**VENETA PLANNING COMMISSION
STAFF REPORT**

**TENTATIVE SUBDIVISION
OAKLEY ESTATES
File No. S-1-23**

Prepared by: Matt Laird, Community Development Director

Map 2: DSL WD # 2020-0407: Figure 6a. Wetland Delineation, Map Overview

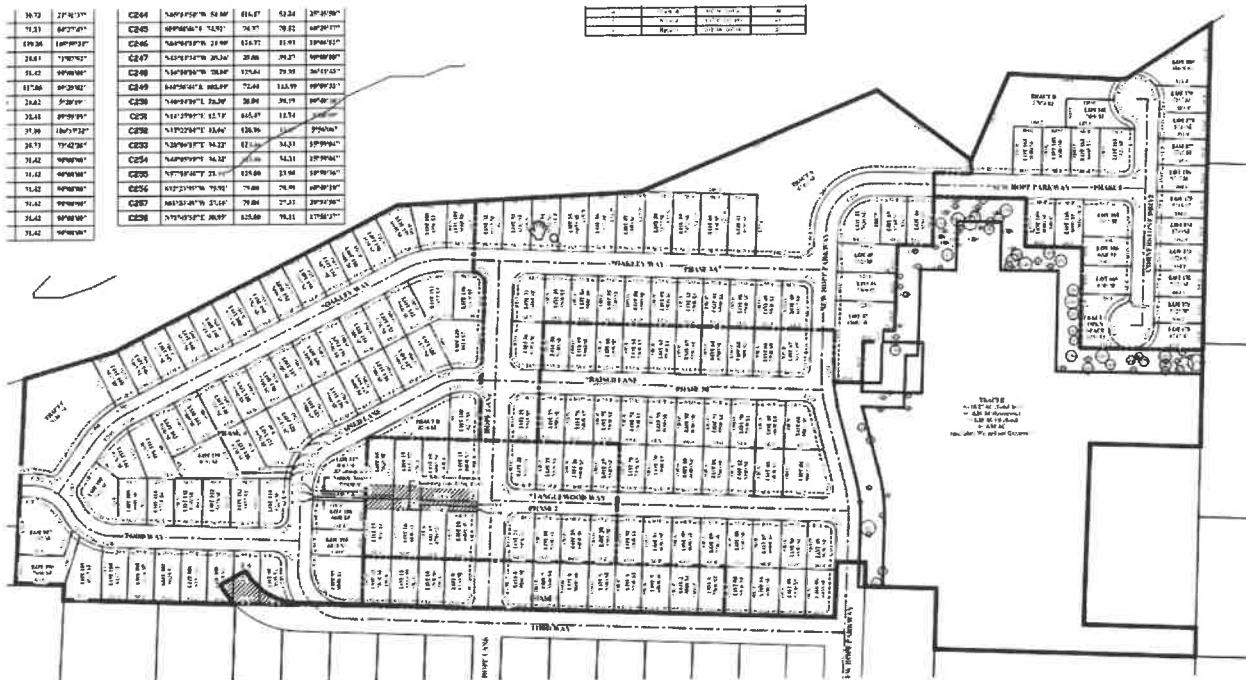
owner, Sue Castillo, submitted comments on this issue. Furthermore, Figure 6a. of the wetland delineation shows there was not a sample plot conducted in this area. Consequently, staff recommends that an additional wetland delineation be conducted on Lot 180 prior to final plat of Phase 5 to ensure there is enough space to construct a home. DSL did not provide any comments on this development proposal, reference DSL Wetland Land Use Notice number WN2023-0244.

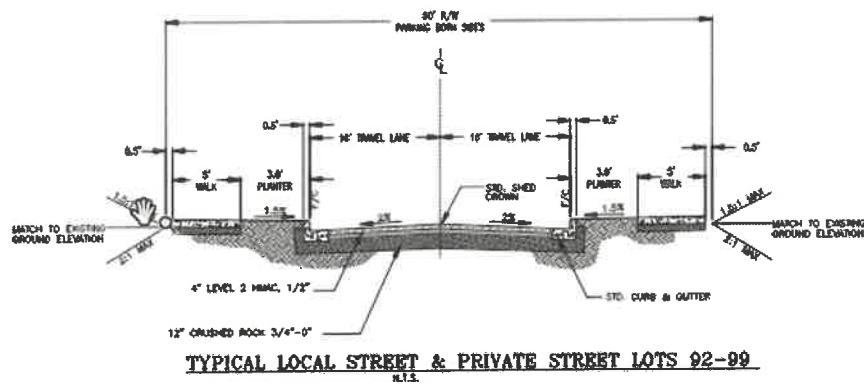
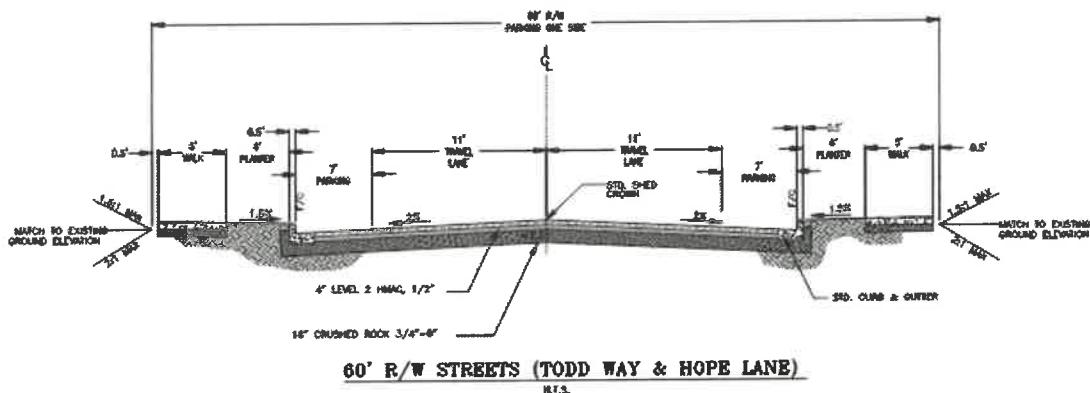
Staff Finding: The applicant's proposed street right-of-way widths meet the minimum standard width for Local and Neighborhood Local streets. The following street sections are included on the Details Sheet C 4.0 of the Oakley Estates Utility Plans.

Staff Finding Continued: The planter strip in the applicant's proposed street section is 3' wide. The City Street Elements table above, shows the minimum width for a planter strip in the City is 4' wide. Furthermore, the table shows the minimum paved curb to curb width is 28' wide and the applicant proposes a 32' wide paved travel surface. The applicant will be required to modify the 50' right-of-way street section to include 4' planter strips. This will be done by shrinking the paved travel surface from 32' wide to 30' wide curb to curb. Additionally, there is a small portion of the west end of Todd Way that is proposed to be vacated. Staff agrees that vacating this section of road is appropriate to facilitate a standard street design. Finally, New Hope Parkway is the second access into the subdivision and it currently does not meet any type of standard for a public local street or neighborhood street. In order to provide adequate secondary vehicle and pedestrian access and emergency access to the site, the applicant will be required to build New Hope Parkway to full standard to its intersection with Jeans Road during construction of Phase 3.

Condition of Approval: Submit a revised 50' right-of-way street section (utility plan Sheet C 4.0). The revised street section will be required to include 5' sidewalk, 4' planter strip, 0.5' curb, and 15' travel lane on each side.

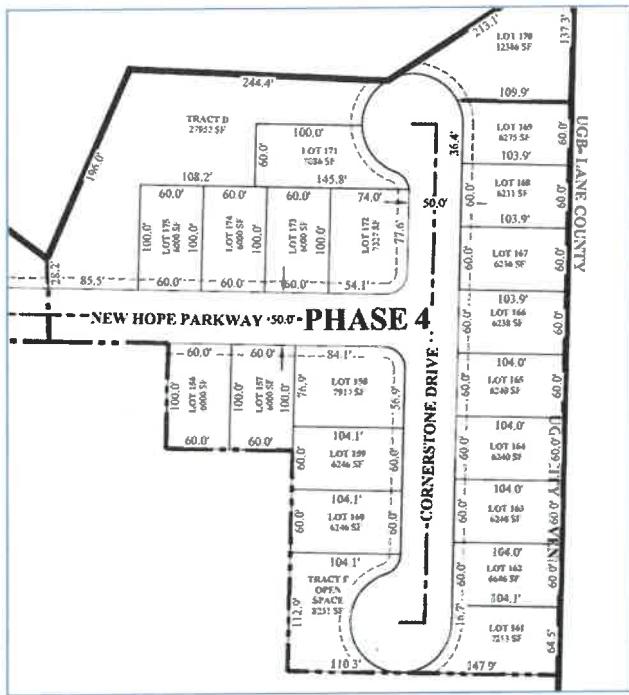
The proposed short street stubs serving Lots 92-99 and 168-172 should either be private drives or end in a cul-de-sac bulb.

Response: Proposed short street stubs serving Lots 92-99 and 168-172 at the north and sound ends of Cornerstone Drive are now proposed to end with cul-de-sacs. Please see attached subdivision⁴⁶ and utility Plans⁴⁷, as well as map snip below from attached subdivision.

Map 9 - A&O Engineering Utility Plan, Sheet C-4.0

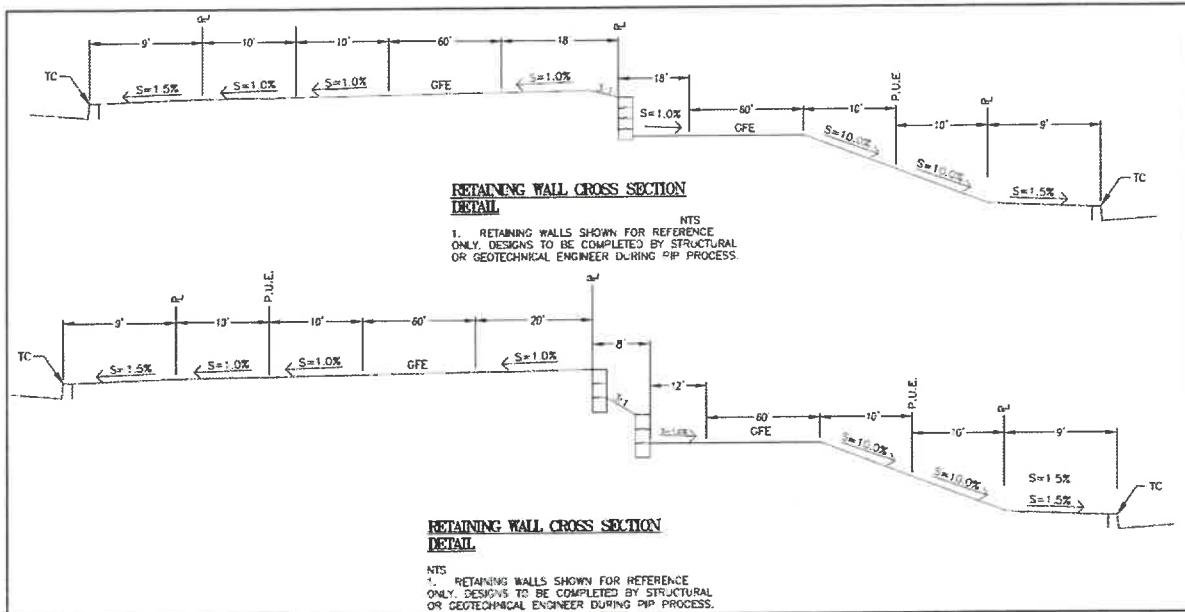
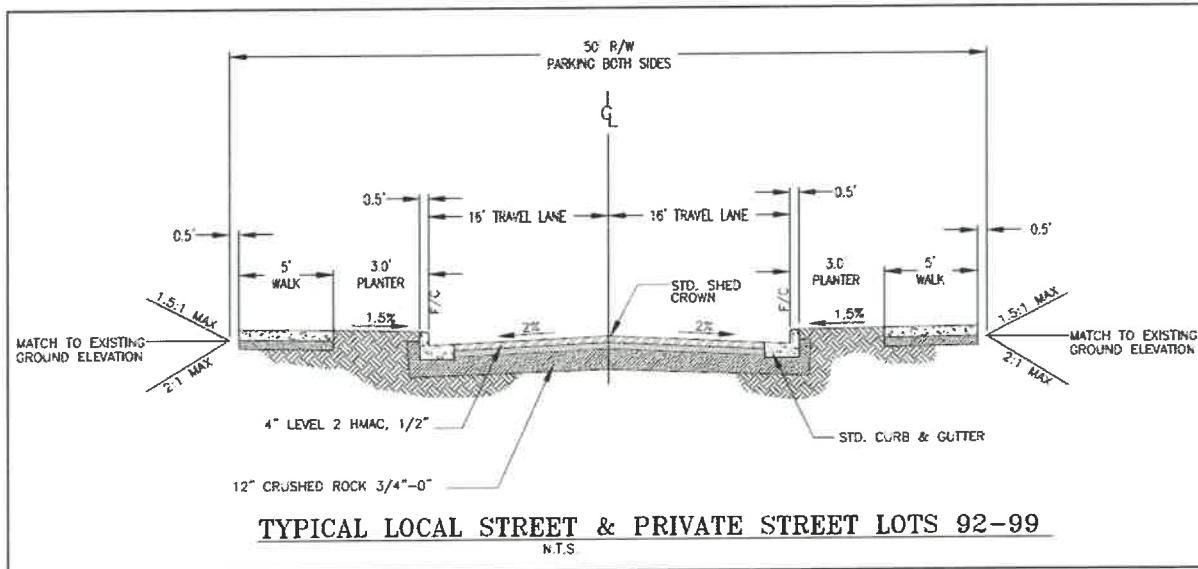
Staff Finding: The proposed street sections are included on the Details Sheet C 4.0 of the Oakley Estates Utility Plans. The proposed 50' right of way street elements that do not meet the standard width are the sidewalk and the planter strip. The applicant proposes a 5' wide sidewalk instead of a 6' wide sidewalk. The 5' wide sidewalk that is proposed can be allowed using the alternative minimum width standard as shown in the Standard right-of-way and street width table found in VLDO 494, Sec. 6.2(2). With regards to the planter strip, the applicant proposes a 3' wide planter strip, however the alternative minimum width included in the table is 4' wide. Therefore, as discussed in the previous finding, the applicant will be required to revise the 50' wide right-of-way street section to include a 4' wide planter strip. This will be done by shrinking the paved travel surface from 32' wide to 30' wide curb to curb.

Condition of Approval: Submit a revised 50' right-of-way street section (utility plan Sheet C 4.0). The revised street section will be required to include 5' sidewalk, 4' planter strip, 0.5' curb, and 15' travel lane on each side. All 50' wide streets must be constructed to meet this standard.
